UNITED STATES PATENT AND TRADEMARK OFFICE

10/523,432

Office Action Summary	Application No. 10/523,432	Applicant(s) ICHIKAWA ET AL.	
	Examiner Vladimir Imas	Art Unit 2839

DETAILED ACTION

FIG. 1

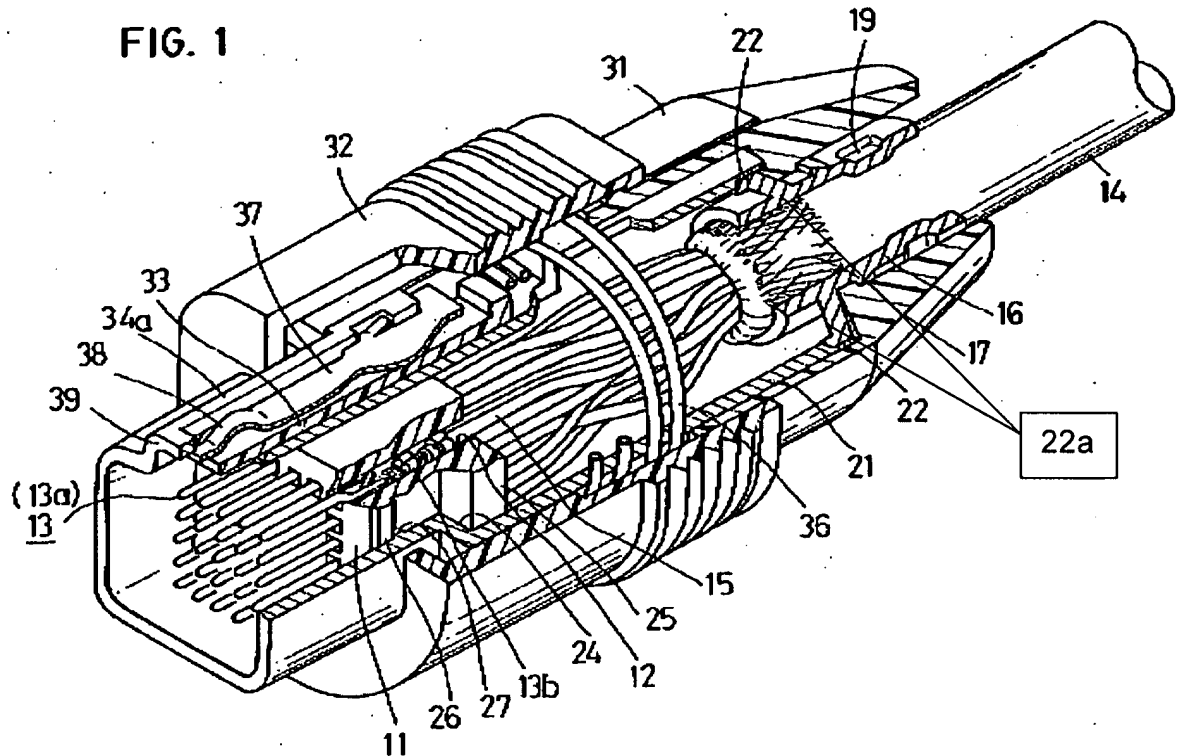
Regarding Claim 1, Komatsu discloses an electrical connector Fig. 1-10 comprising: a shield case 21 for covering an insulative housing 11 mounting a plurality of terminals 13, each of the terminals having a contact piece 13a and a terminal piece 13b, at least a portion of the terminal piece extending from the insulative housing in a direction away from the contact piece, the terminal piece being capable of being connected to an electric wire 15 of a cable 14; an over-molding portion 31 for securing the shield case along with the cable to shape the electrical connector; the shield casing having a tube-like 21a portion engaging with a portion of the insulative housing and a box-like 21b portion internally receiving at least a portion of the terminal piece and the electrical wire of the cable; the tube-like portion and the box-like portion being connected via a continuous piece 21c, the tube-like portion including a bending piece 24 externally projecting from an edge of the tube-like portion, the continuous piece and the bending piece being embedded in the over-molding portion.
